1 HAMPSHIRE STREET

Supplementary Design and Access Statement for the London Borough of Camden

PURPOSE OF DOCUMENT

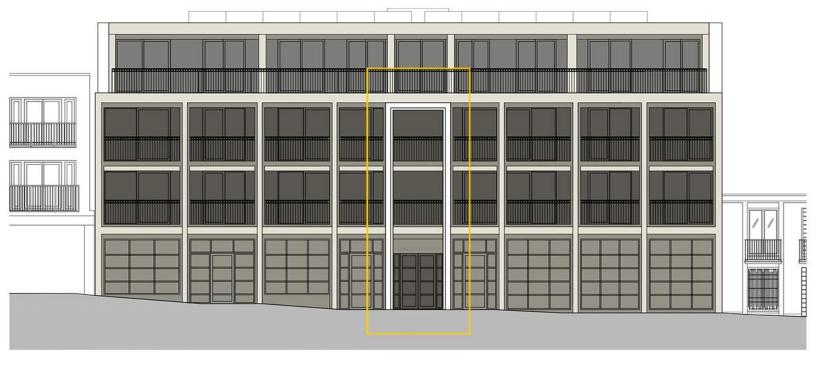
- The building has a clearly expressed structural frame divided by the inset balconies. The irregular proportions of the bays along with the stepped building line create an overcomplicated elevation. Furthermore the vertical elements don't relate to the internal layouts, creating a visible secondary structure. A regular vertical frame that has a relationship to the internal layout would help the building to read more coherently.

With regards to the councils comments on the previous proposal, the elevation has been simplified by eliminating the stepped bays across the building. This has allowed for the frame, bays, and recessed terraces to fit to a more regular pattern, and to keep them in proportion, as shown in figure 1 and 3. The elimination of the stepped facade has also allowed for a better relationship between the structural frame and the internal structure, with the outer frame and the recessed elevation now following a similar rhythm across the building, as shown in figure 4.

3. Framed by the set back lighter coloured brick previously mentioned, the deeper recesses in the facade are solely for the residential entrance and residential terraces. The depth of these recesses strengthen the impression of the building as being carved out of mass, and serve to clearly delineate the residential from the commercial, the ground floor unit fronts being flush with the light brick surround.

4. To maintain a pattern and rhythm across the elevation, the recessed brick panels of the residential units are carried up through the building where possible, creating another layer, related to but behind the primary elevation, and symmetrical about the centre of the building.

project:	17-010 - 1 Hampshire Street, London NW5 2TE					
drawing:	PROPOSE	PROPOSED SECOND FLOOR PLAN				
date:	26.01.17	26.01.17 drawn by: LM				
scale:	1:100@A3	drwg no.: 312	rev. no.: P.04

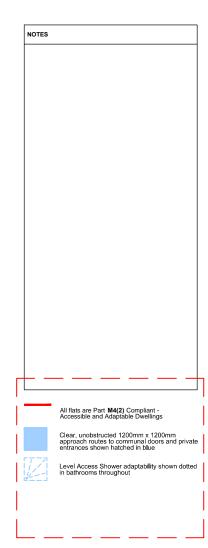
- The communal entrance doors did not provide minimum clear opening width of 850mm for at least one door leaf.
- The door to refuse store not accessible as there was not an 850mm clear opening width to at least one door leaf.
- The flat entrance doors did not appear to provide a clear opening width of 850mm with a 300mm nib on all doors.
- Not all the units had a WC with an outward opening door.
- All the units showed baths but no level access showers
- Not all the kitchens provided 1200mm in front of all units.

- As there are 16 units there should have been at least one unit designed to M4(3) standard.
- The retail unit entrance doors did not offer a clear opening width of 1000mm for at least one door leaf.
- The width of the public path in front of the building does not reach a uniform width of at least 1100mm

Additional notes indicating compliance with Part M4(2)

PROPOSED ELEVATION SCALE 1:100

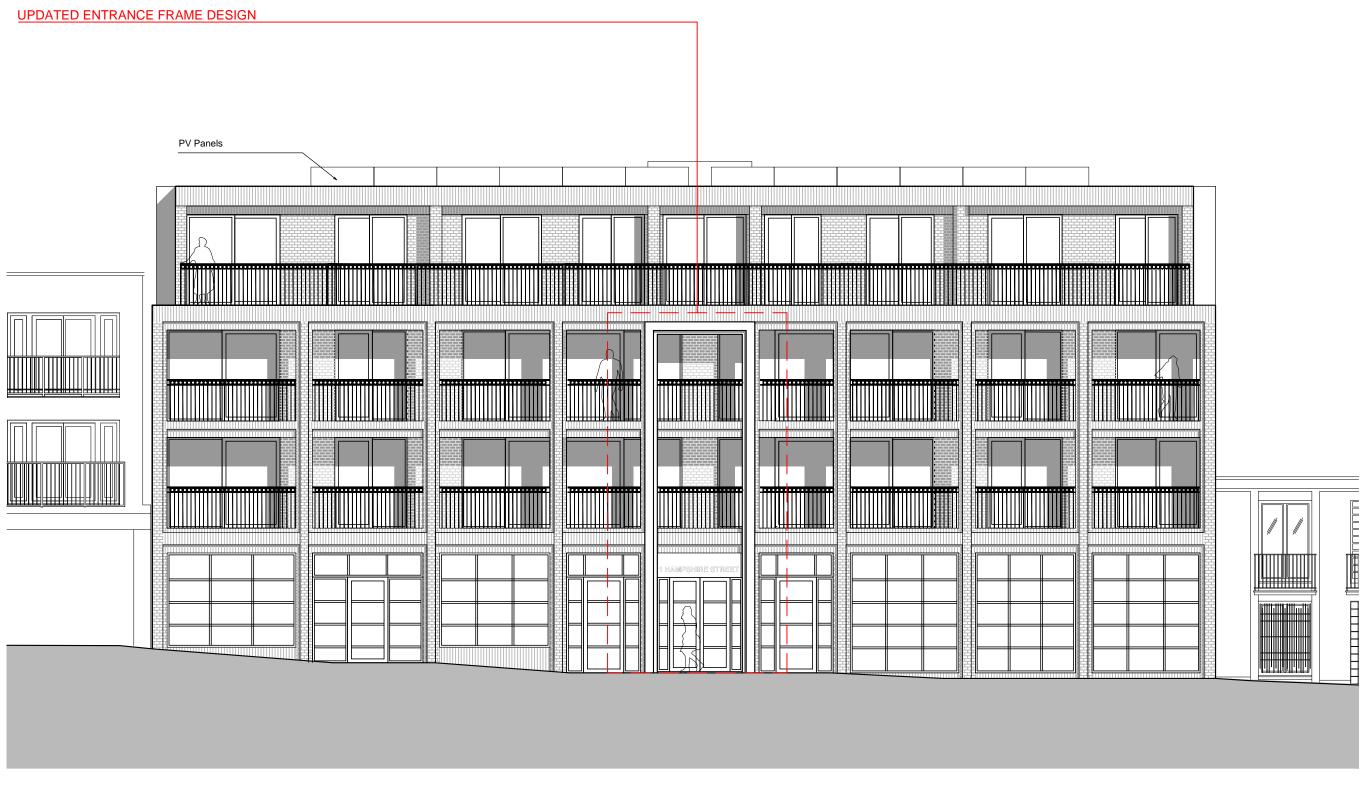
- The building is stepped along the front façade to meet the line of both neighbouring buildings. While some stepping in the building line would be acceptable, the proposed five steps in the building appears overly complicated and would create unwanted nooks and crannies along the street. This is of particular concern in this area as it is at the end of a street that could be prone to anti-social behaviour. Reducing the amount of steps in the building would help simplify the elevation and create an improved street environment.

- The building facade no longer steps, but has a slight change of angle along the street, in order to reflect the site boundary.
- The bays have been changed to a more regular, symmetrical pattern, the elevation has been simplified, and the vertical frame has been made more regular, and more closely related to the internal structure and recessed facade.
- The entrance door has been brought closer to the street, leaving only a 900mm overhang for shelter, eliminating a potentially unsafe space.

FACADE IS NO LONGER STEPPED, RUNS IN LINE WITH SITE BOUNDARY

ELEVATION ALTERED TO IMPROVE PROPORTION AND RELATIONSHIP WITH INTERNAL STRUCTURE
